Davis-Besse Nuclear Power Station  
5501 North State Route 2  
Oak Harbor, Ohio 43449-9760

Subject: License Amendment Application to Revise Technical Specification (TS) 3/4.9.4, Refueling Operations - Containment Penetrations, TS 3/4.9.12, Refueling Operations - Storage Pool Ventilation, and Associated Bases Regarding Containment Equipment Hatch Cover Requirements (License Amendment Request 00-0005)

**SAFETY ASSESSMENT AND SIGNIFICANT HAZARDS CONSIDERATION  
FOR  
LICENSE AMENDMENT REQUEST NUMBER 00-0005**

Proposed Revisions to Technical Specification (TS) 3/4.9.4, Refueling Operations - Containment Penetrations, TS 3/4.9.12, Refueling Operations - Storage Pool Ventilation, and Associated Bases Regarding Containment Equipment Hatch Cover Requirements

Figure 1

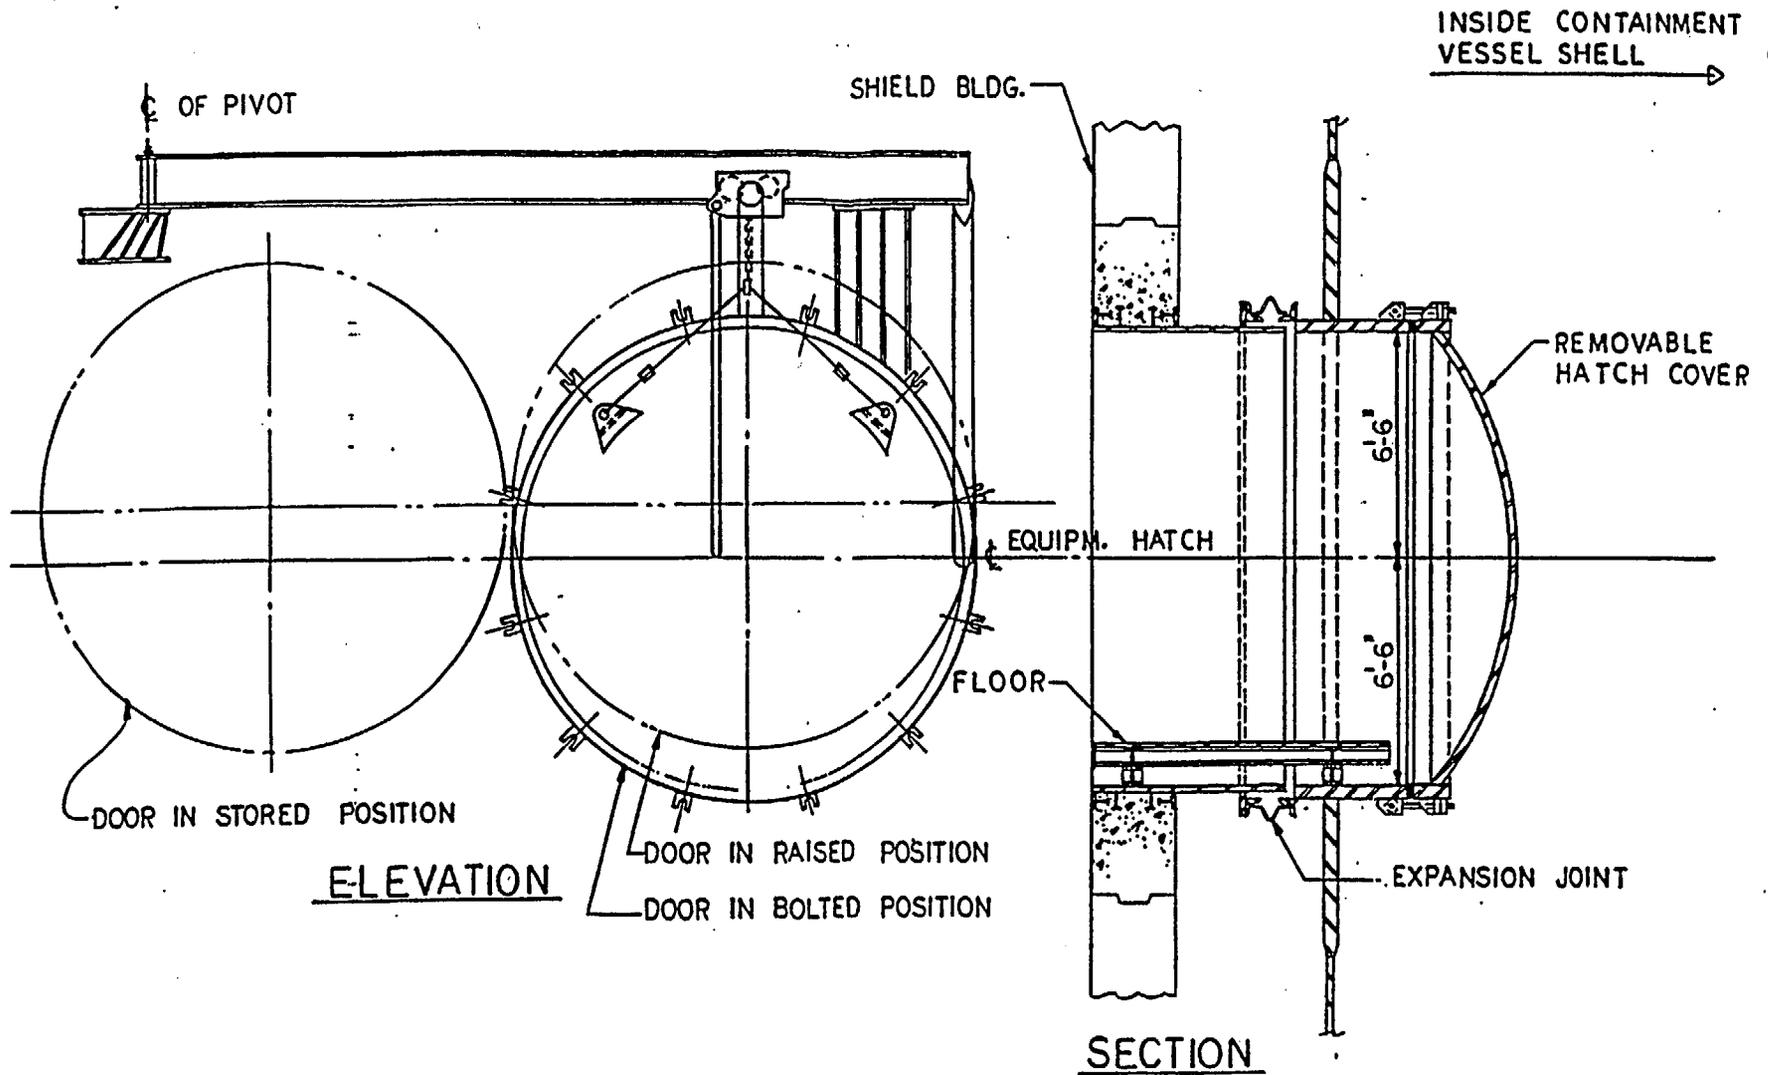
The containment equipment hatch cover (shown in attached Figure 1) is located inside containment and must be completely unbolted, raised, and moved to the side through the use of a chain hoist and monorail in order to allow access. Returning the containment equipment hatch cover to a closed position requires that the closure personnel remain inside containment, move the hatch cover along the monorail, lower it into position, and align the bolt holes. After bolting the cover into place, closure personnel then exit through the personnel air lock.

Figure 2

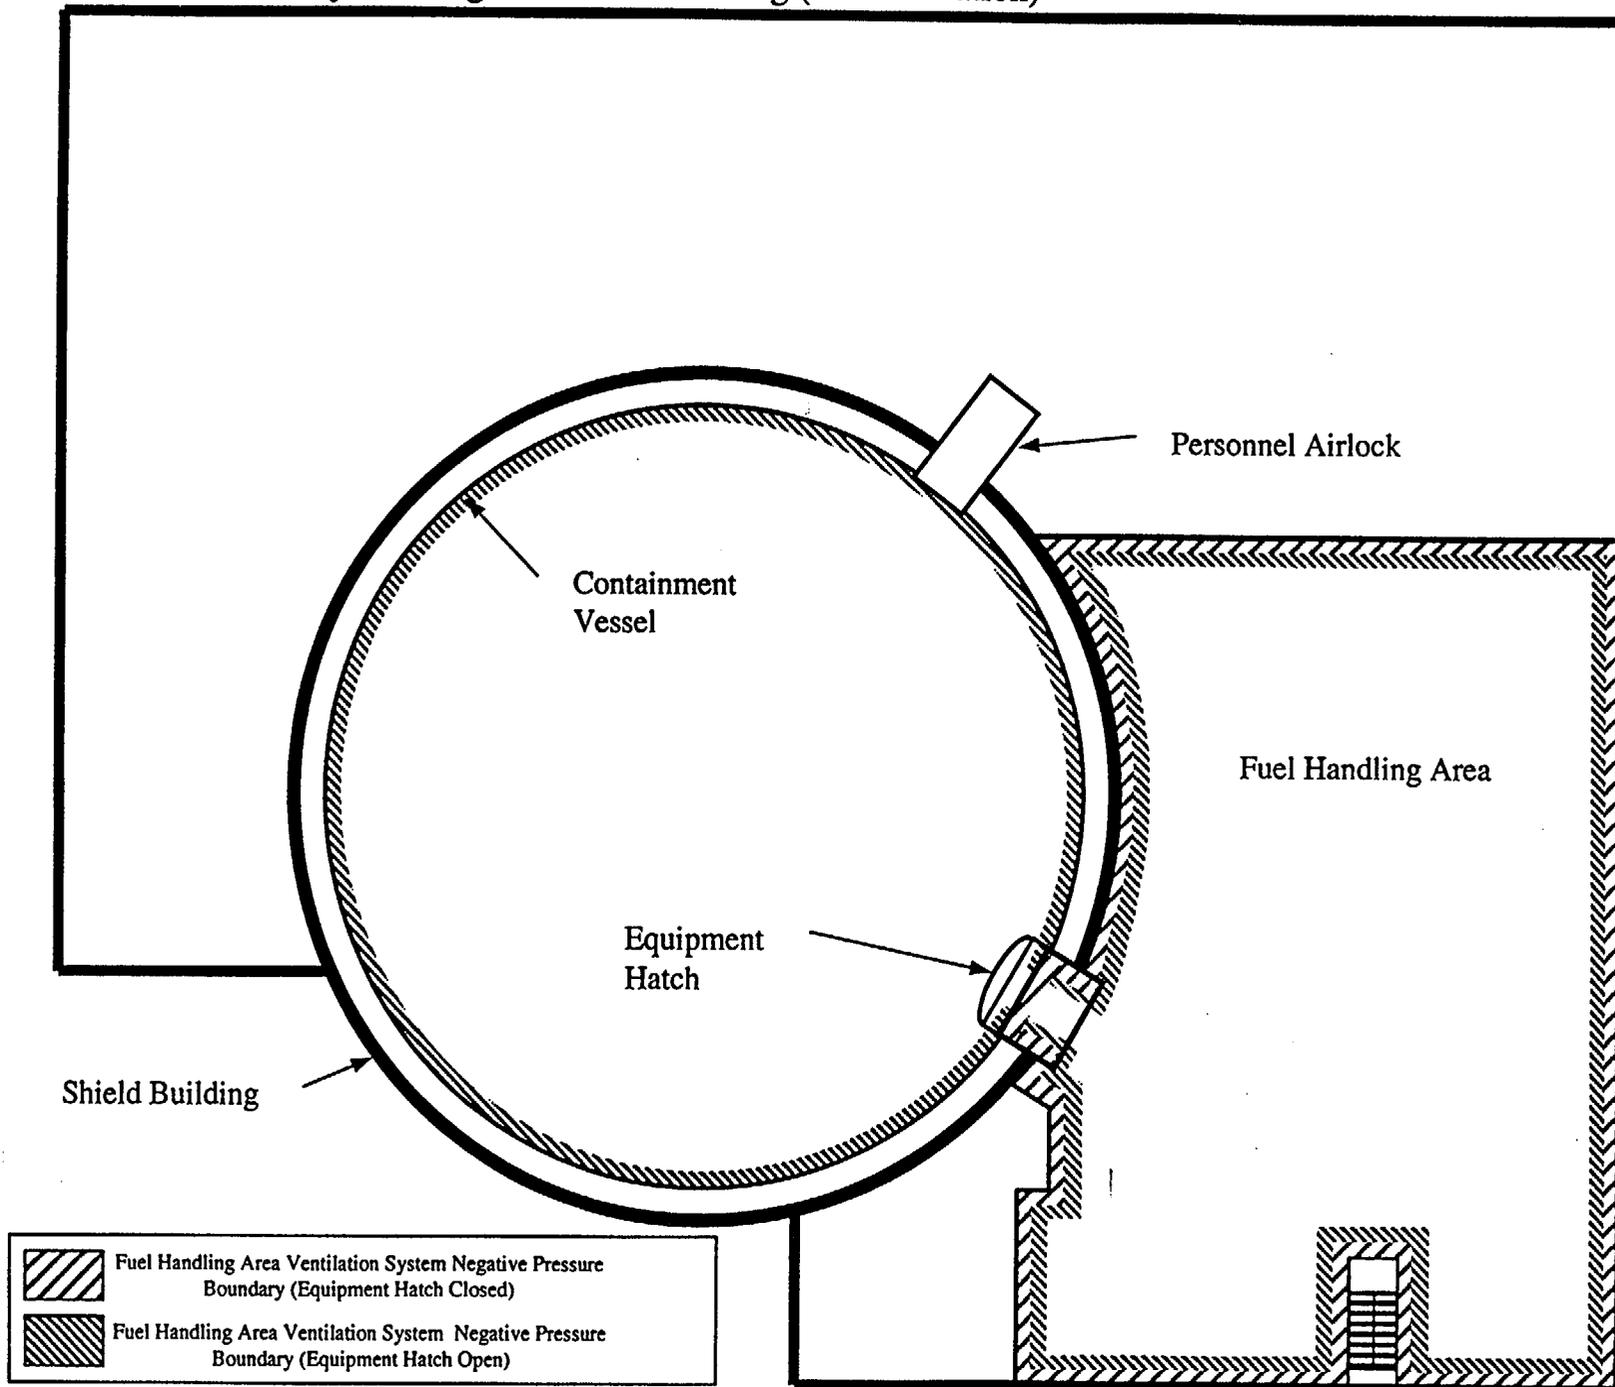
As depicted in Figure 2, the containment equipment hatch opens into the fuel handling area and not into the out-of-doors environment. This area is serviced by the Emergency Ventilation System (EVS), which can draw air from this area and filter it through high efficiency particulate air filters and charcoal adsorbers prior to discharge to the out-of-doors environment.
